4 February 2021

Selwyn District Council
Attention: Jocelyn Lewes

**PRIVATE PLAN CHANGE REQUEST TO THE OPERATIVE
SELWYN DISTRICT PLAN- RFI
PC200073: DUNNS CROSSING ROAD, ROLLESTON**

Figure 1. Location plan including relevant features.

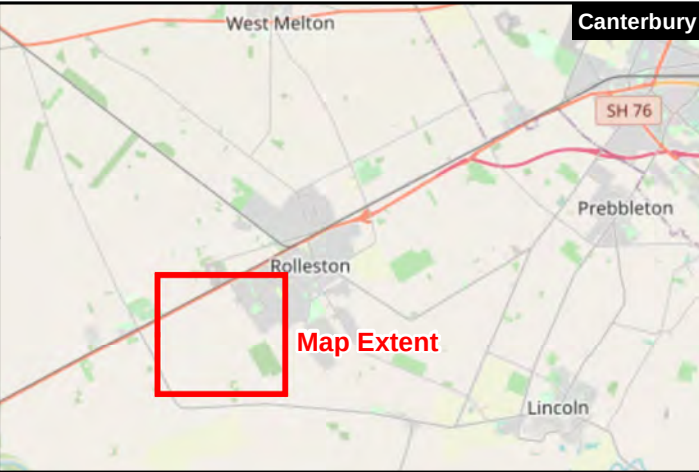
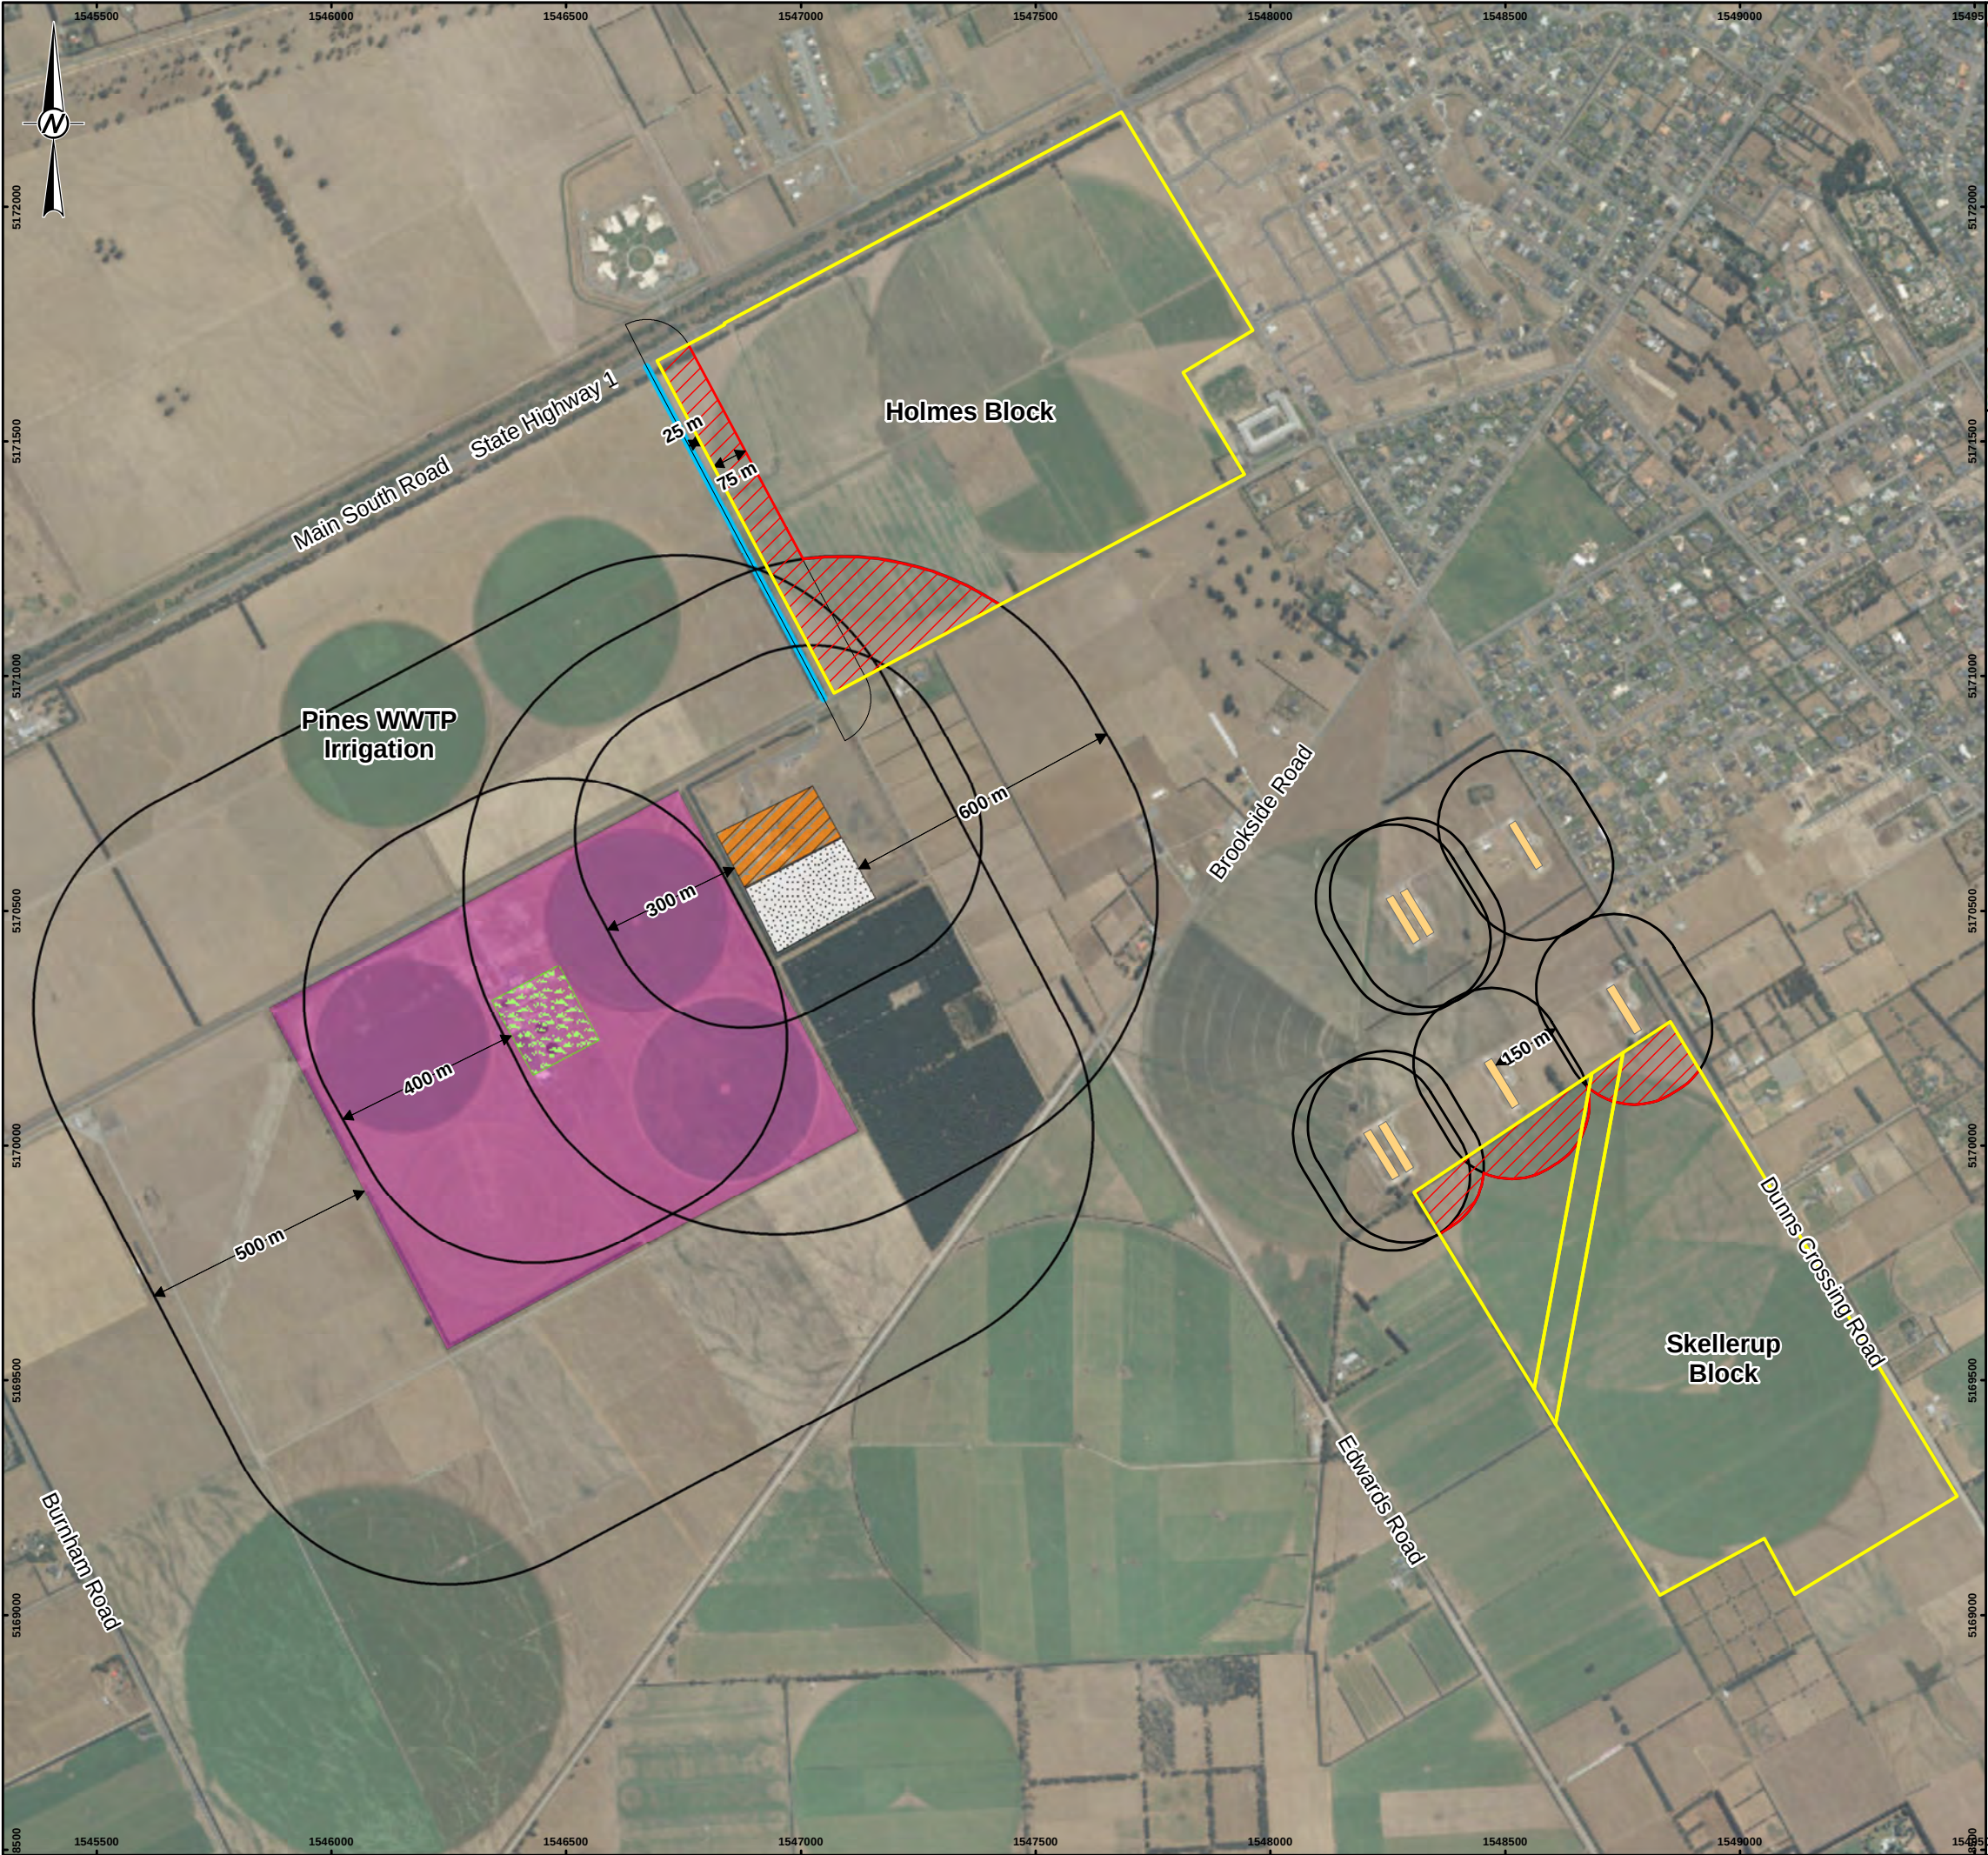
Response:

65. It is agreed the maps were incorrect and an updated map is attached to Golder's assessment in **Attachment 1** (Figure 1). The tabulated values presented have been maintained.

It is agreed the maps were incorrect and an updated map is attached to this letter (Figure 1). The tabulated values presented have been maintained.

OUTLINE DEVELOPMENT PLAN 39 - HOLMES BLOCK

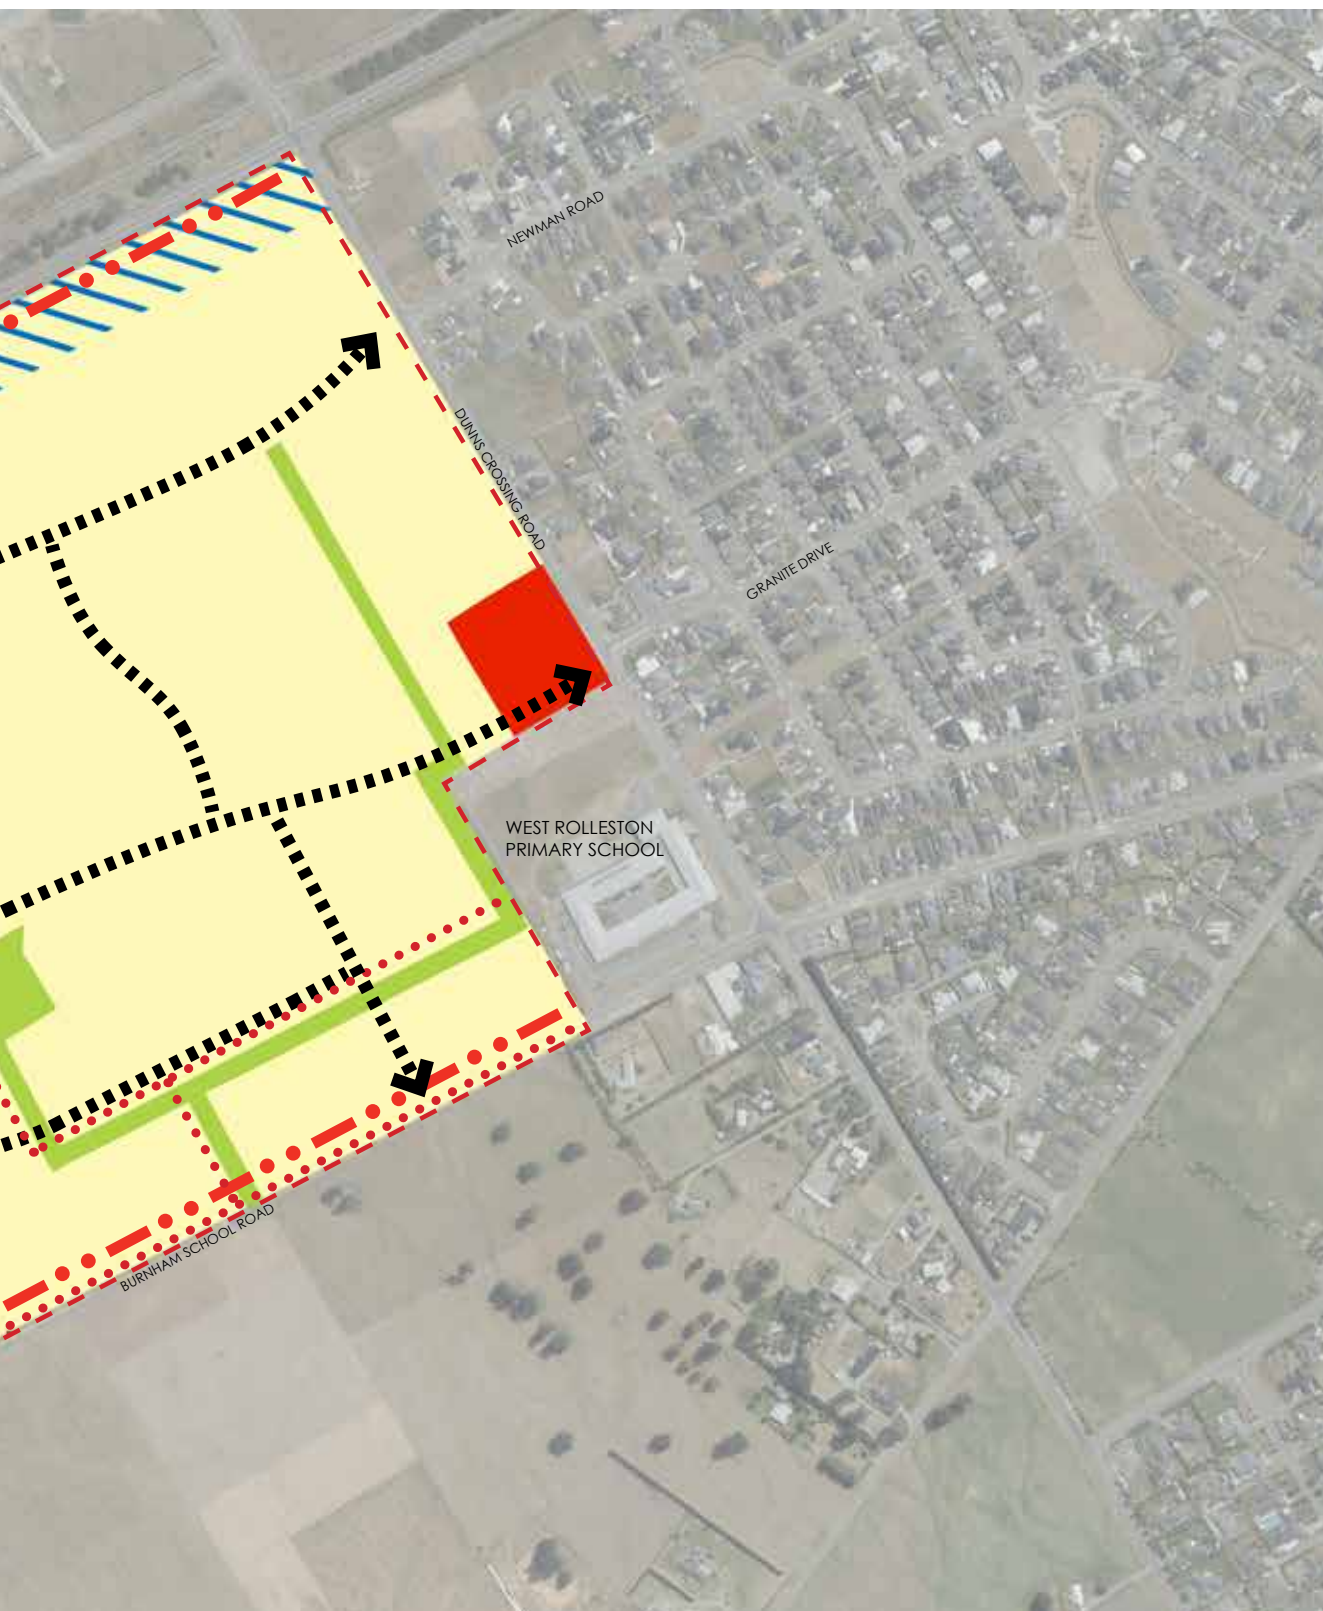
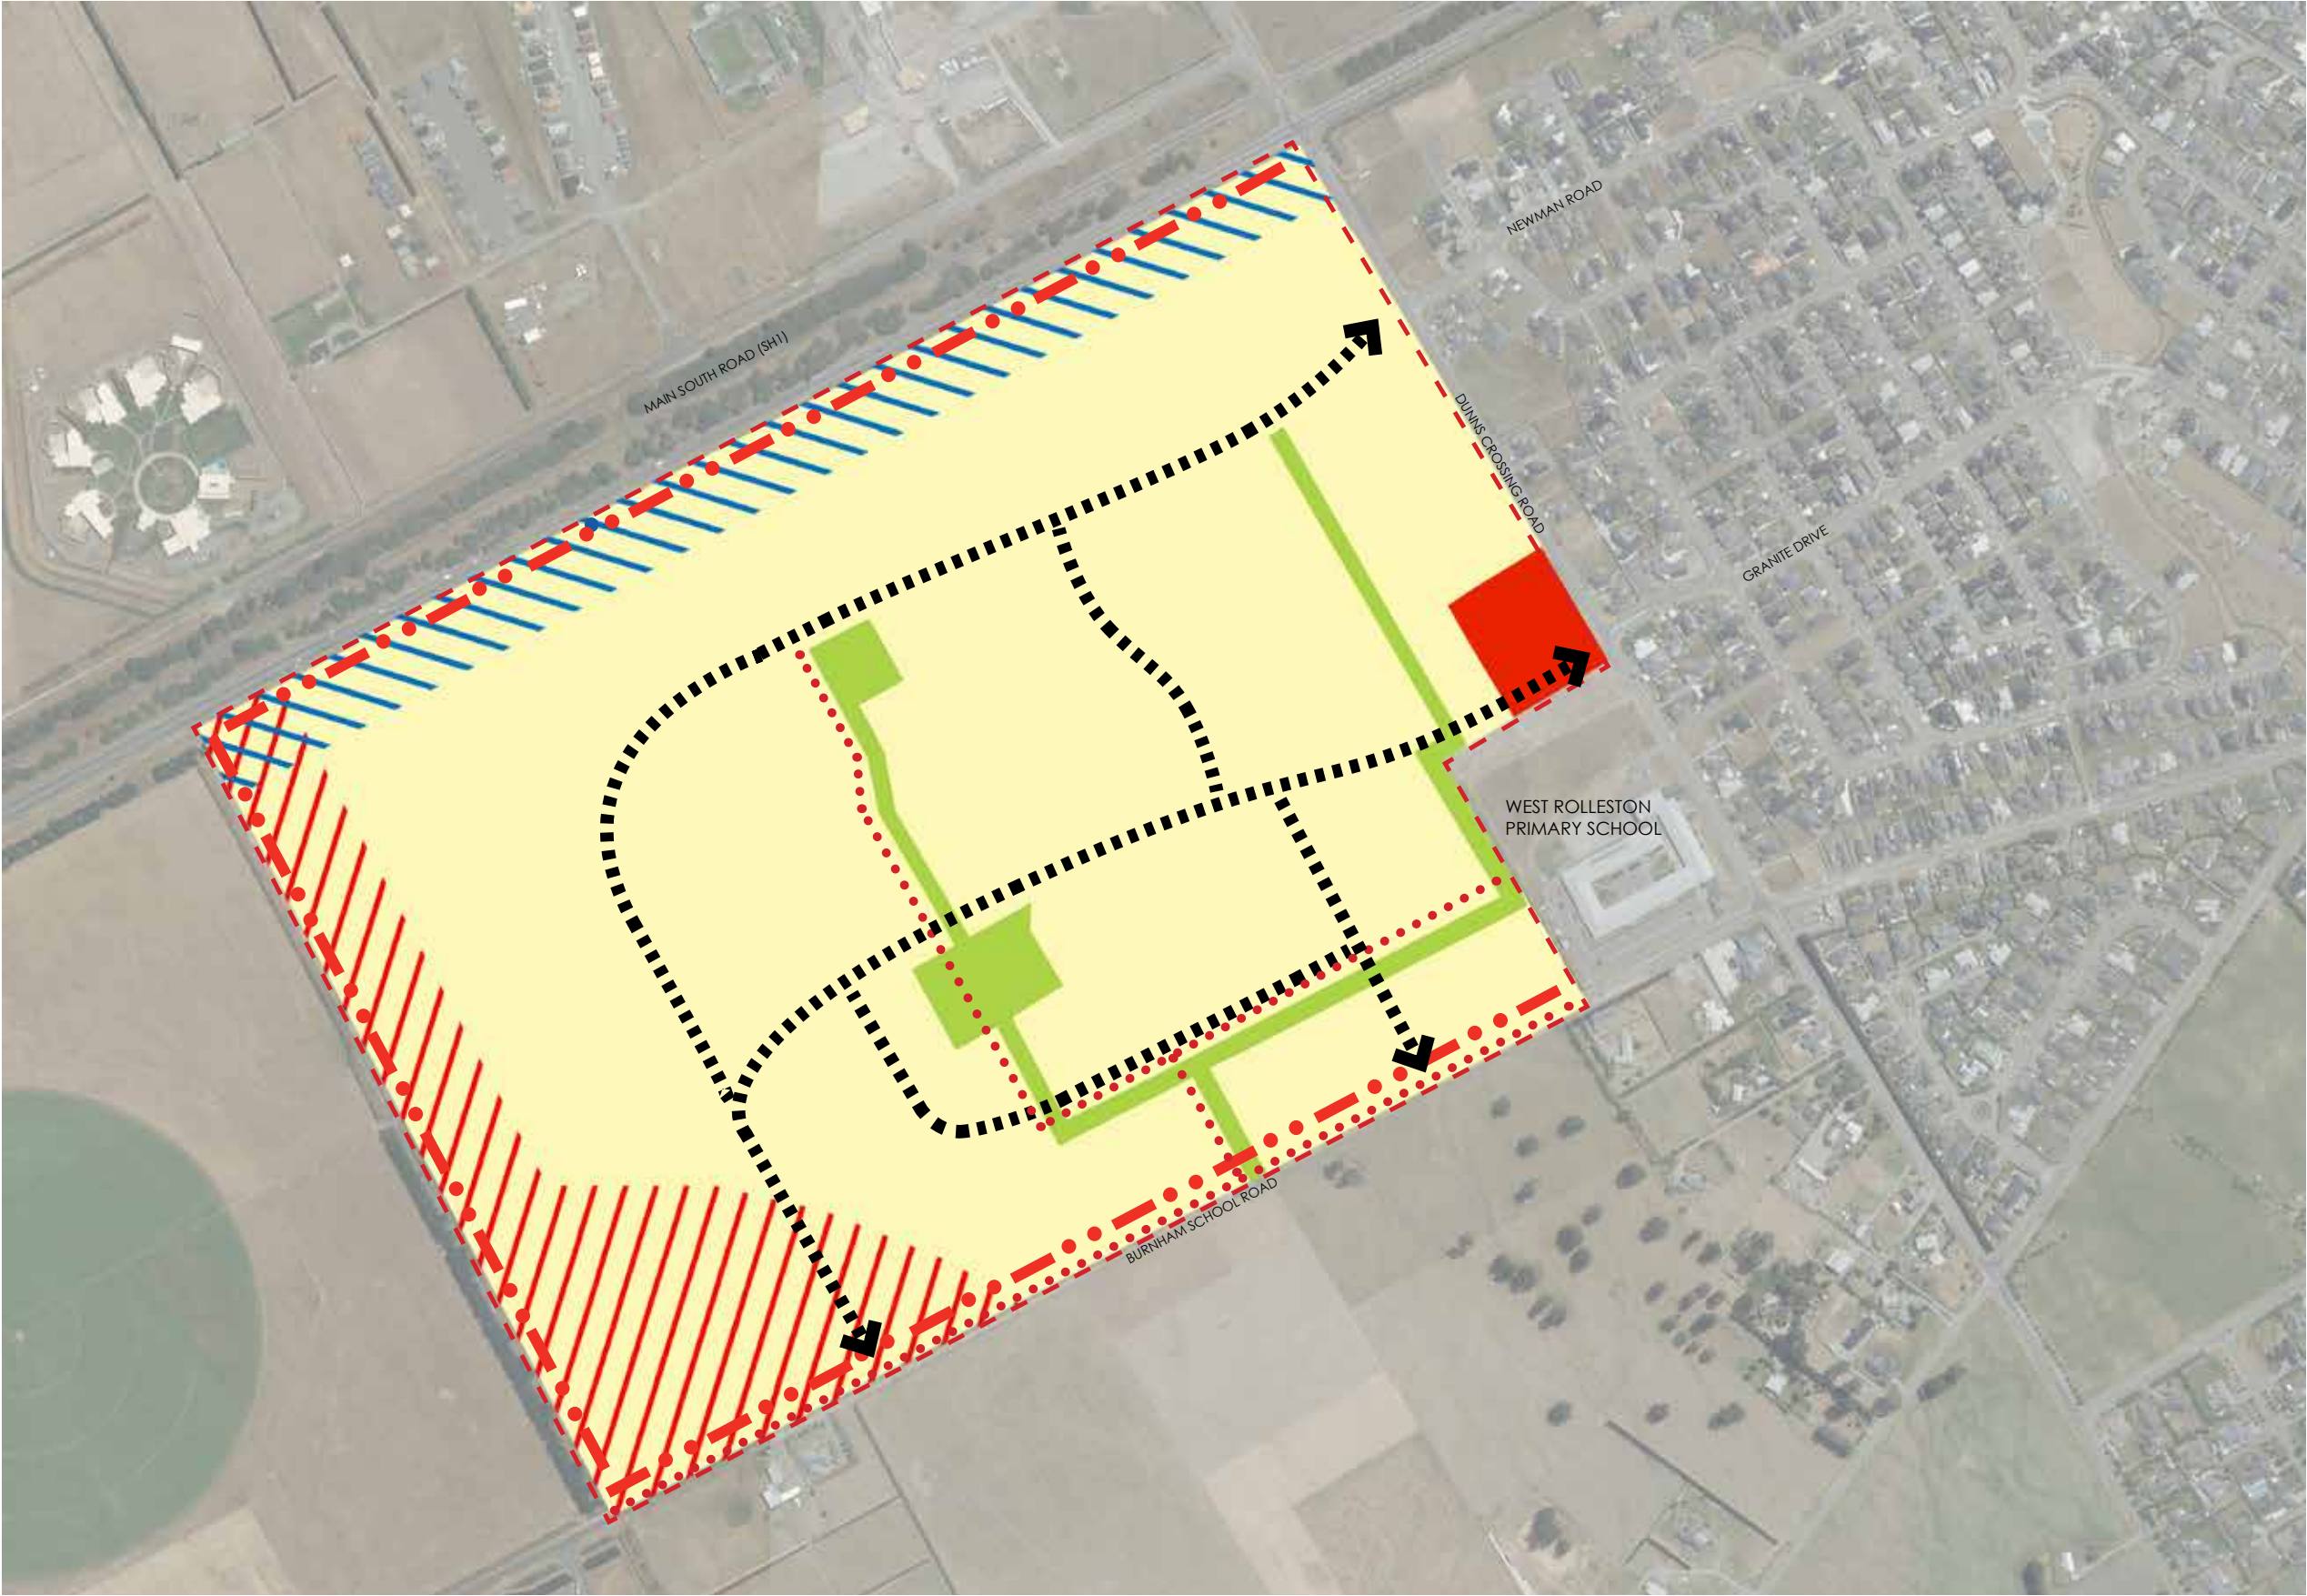
15. *The open space provision and location in the Holmes Block area is generally supported with a reserve and pocket park located adjacent to higher density residential development, and readily accessible to future residents. However, clarification is requested around the function of the 'green links' shown on the ODP. Some align with the roading network and shared footpaths – will these be widened road reserves like the Faringdon boulevards and, if so are they needed? Please provide further explanation to ensure they are warranted, and where not adjoining roading, do not create long narrow linkages. Further, please provide a rationale for the green link shown on the Holmes Block extending out to SH1, and whether this is intended to be open to pedestrian access to SH1.*

24. Please amend the Holmes Block ODP to show provision of an off road walkway/cycleway along Burnham School Road to Dunns Crossing Road, along with a walk cycle link as below to Burnham School Road (as shown below).

32. The reserve layout has been amended so there is no green linkage extending out to the State Highway and a new green link has been added to connect to Burham School Road.
33. The greenways are anticipated to be approximately 10m wide and are proposed to provide a high amenity green link between residential blocks, allowing for off-road pedestrian and cycle movement. Furthermore, they intercept and focus people's movements towards the West Rolleston Primary School and the commercial/business area. Pockets of native planting will be added along the corridor to assist with biodiversity and adding to the ecological value of the spaces.
34. These amendments are shown in the revised ODP included in **Attachment 3**.
